R.E. Ginna Nuclear Power Plant

**Subject:** Response to Request for Additional Information  
Regarding R.E. Ginna Nuclear Power Plant  
Relief Requests VR-1, VR-2, and VR-13 for  
The Fourth 10-Year Interval Inspection  
Docket No. 50-244

### Response to NRC Request for Additional Information (RAI) Dated June 15, 2004

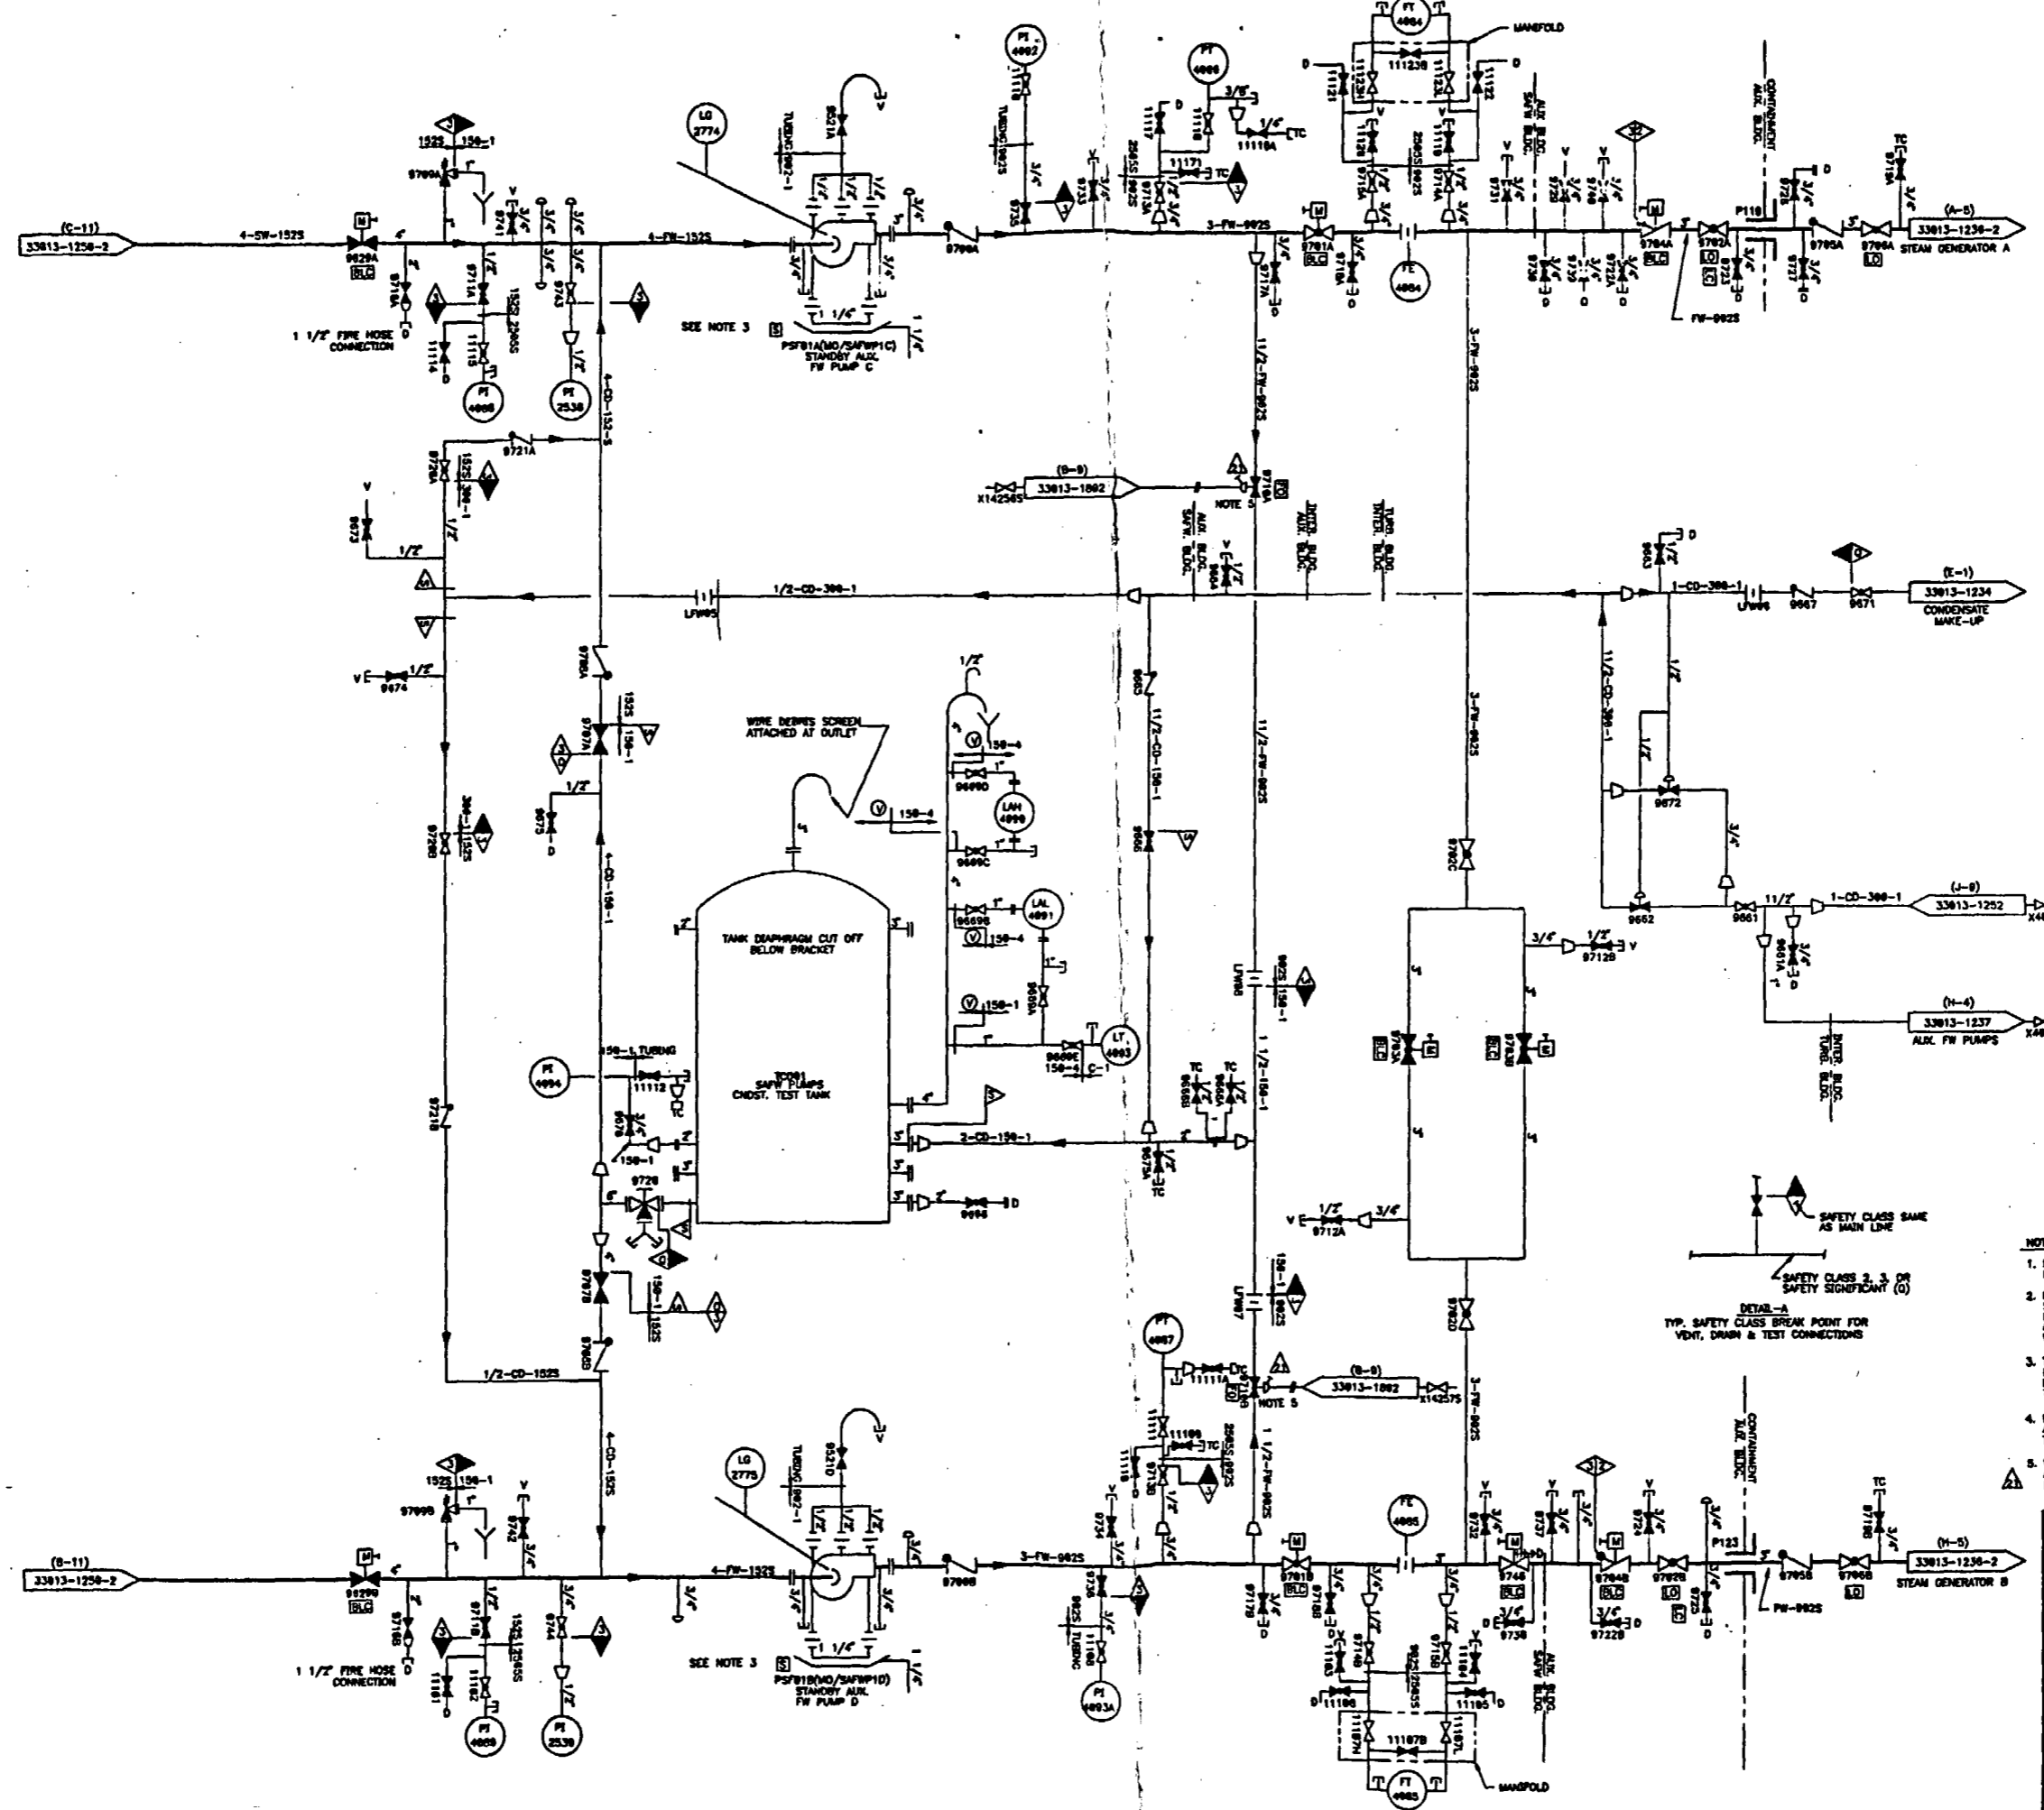
**RAI 6: Provide sufficient information for NRC staff to reach a safety or risk determination with regards to isolation of these check valves when testing on-line. Also provide copies of drawings (P&IDs) showing check valves and isolation valves and provide details how isolation of these check valves will be established.**

**Response:** As noted in response 1 above, these valves will not be full flow tested. As shown on the attached drawings (33013-1250 sheet 2 of 3 coordinates B-9 and B-10, and 33013-1238 coordinates B-1 and I-1) these valves are in the service water line to the standby auxiliary feedwater pumps. The standby auxiliary feedwater pump will be isolated at the time that the valve inspection and disassembly take place. On the service water side, isolation will be performed by a 4 inch isolation valve (9626A or 9626B as shown on drawing 33013-1250 sheet 2 of 3 coordinates A-2 and B-3). There is no

difference in isolation, regardless of the plant status. On the downstream side there are a number of isolation valves between the check valve and the steam generator (including three check valves and numerous isolation valves as shown on drawing 33013-1238).

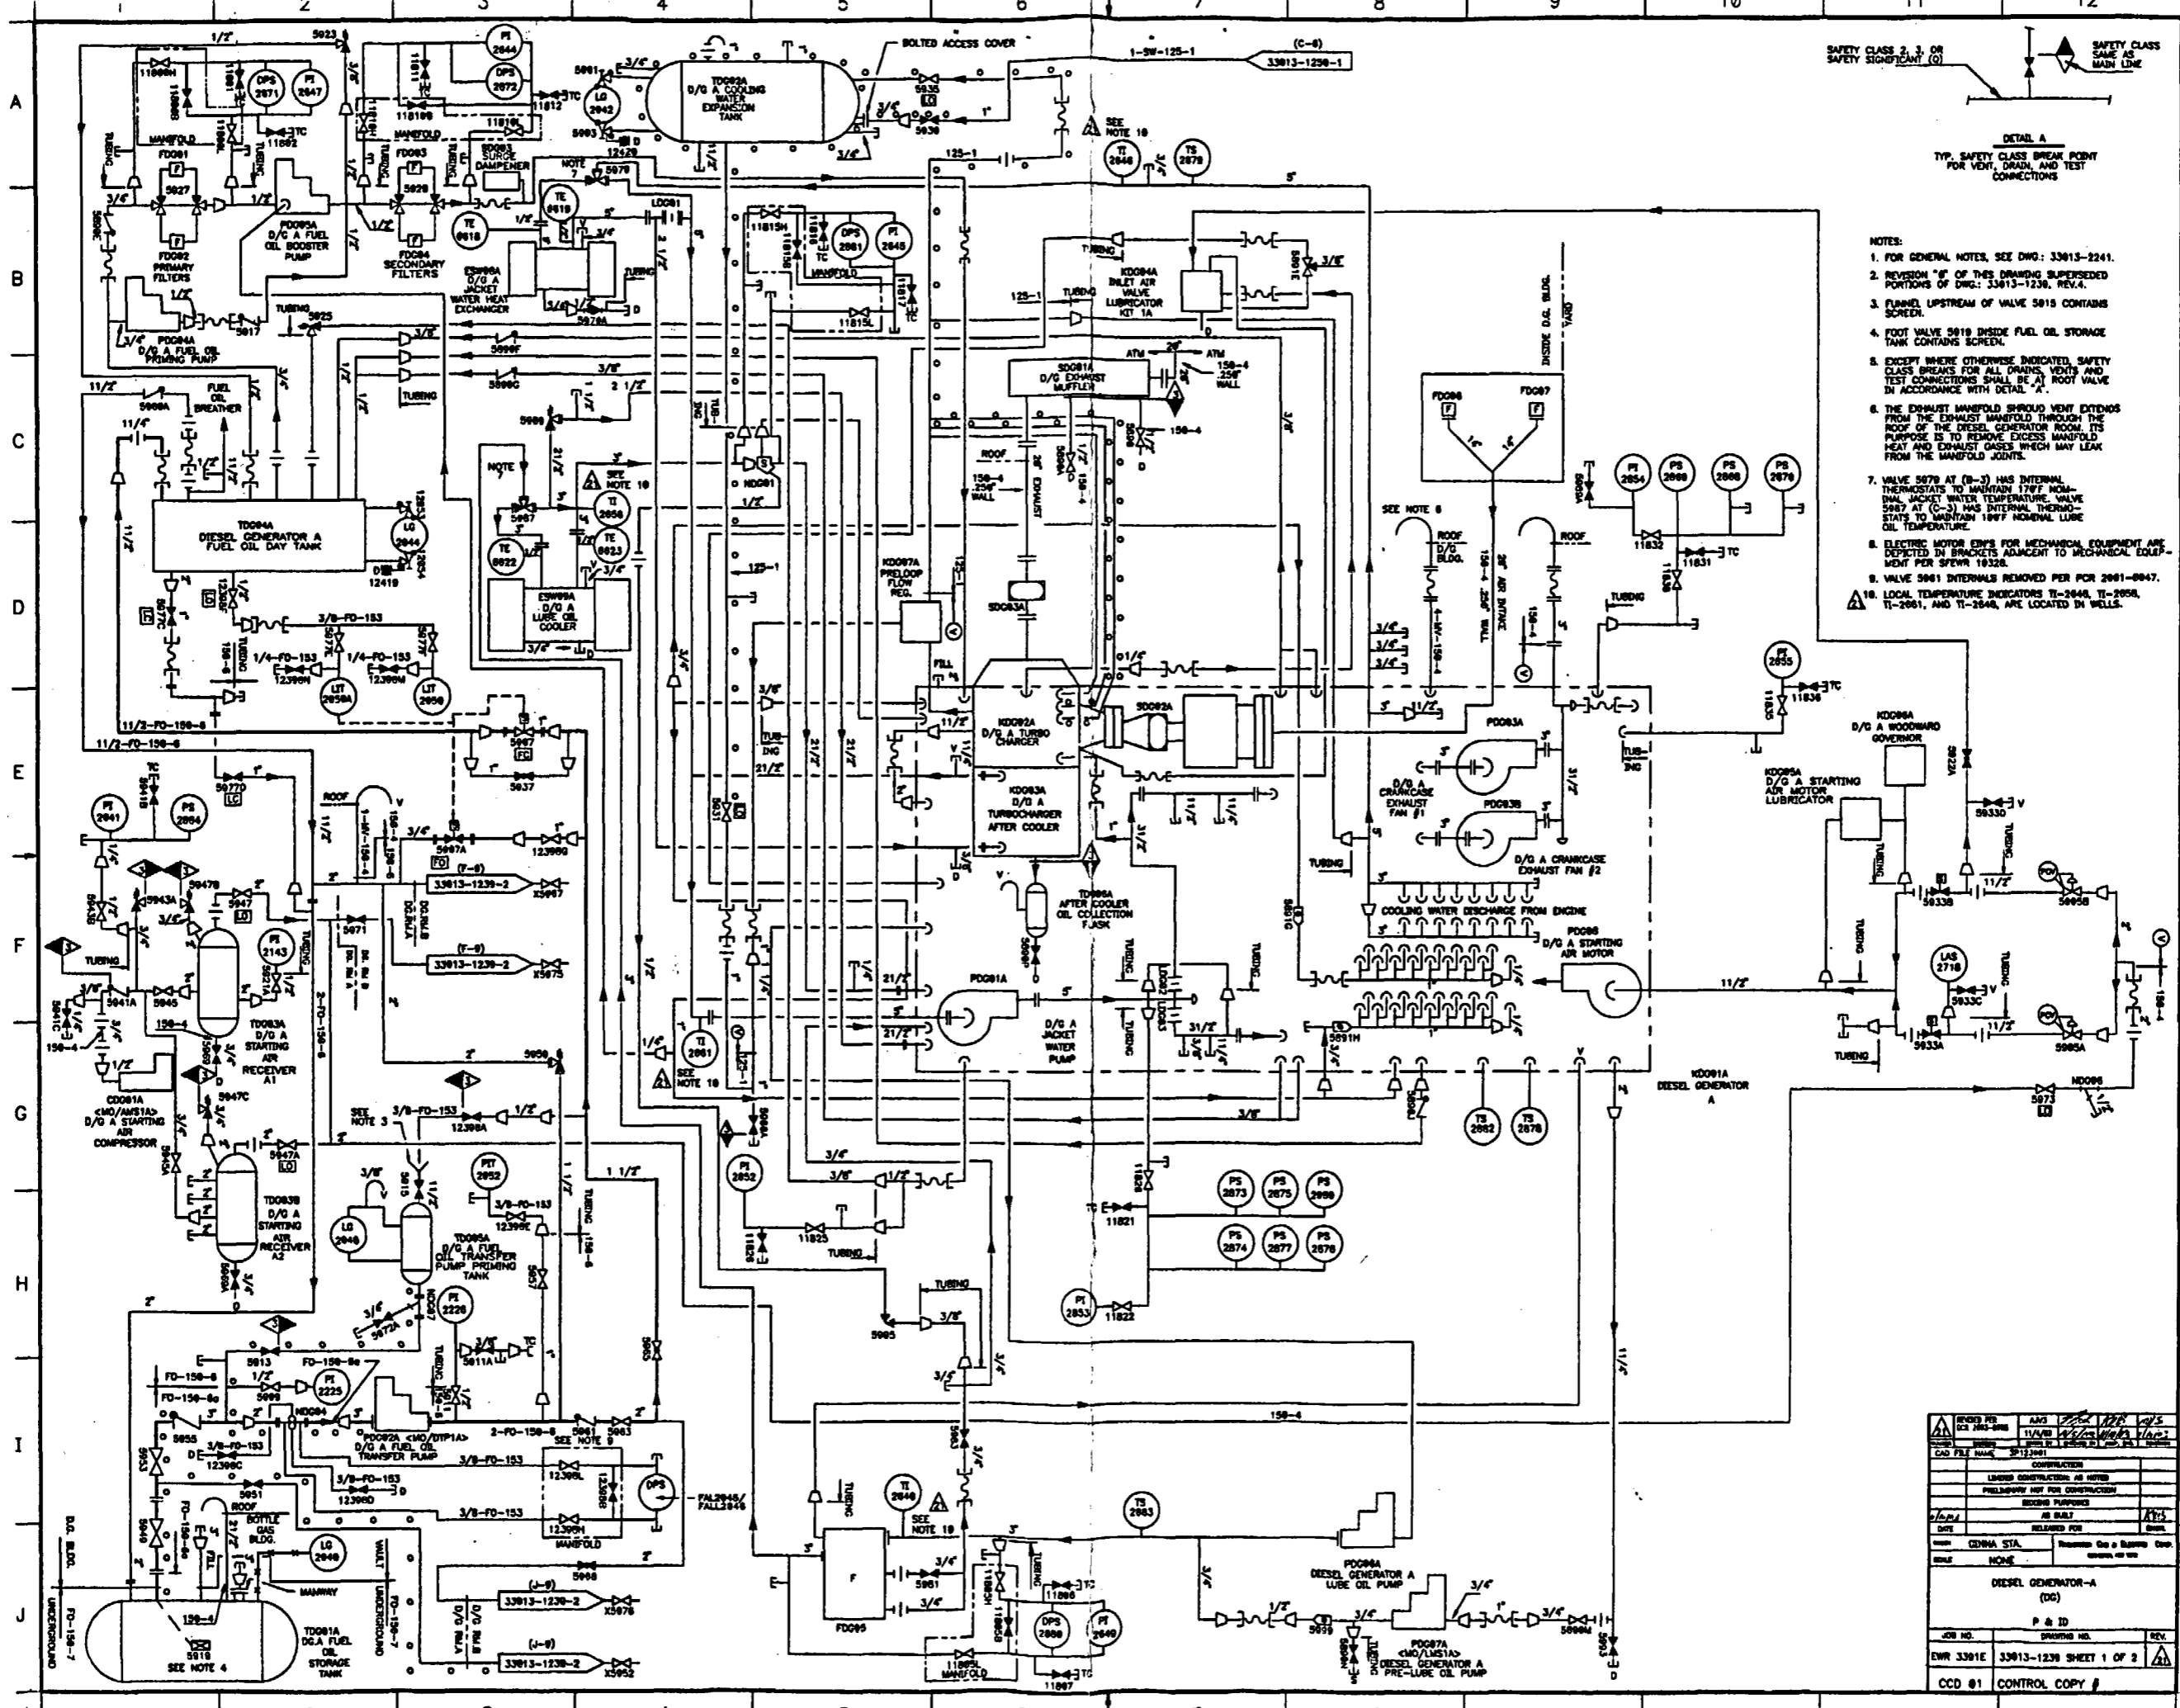
**RAI 6: Provide sufficient information for NRC staff to reach a safety or risk determination with regards to isolation of these check valves when testing on-line. Also provide copies of drawings (P&IDs) showing check valves and isolation valves and provide details how isolation of these check valves will be established.**

**Response:** As noted in response 1 above, these valves will not be flow tested. As shown on the attached drawings (33013-1239 sheet 1 of 2 coordinates C-1 and 33013-1239 sheet 2 of 2 coordinates C-11), there is no difference in isolation of the affected line regardless of the plant status. These valves are in the overflow line from the respective diesel generator fuel oil day tank to the underground main storage tank. There are no isolation valves in the flowpath. Instead, the diesel generator and fuel oil transfer pump will be isolated at the time that the valve inspection and disassembly take place. The line is normally drained.
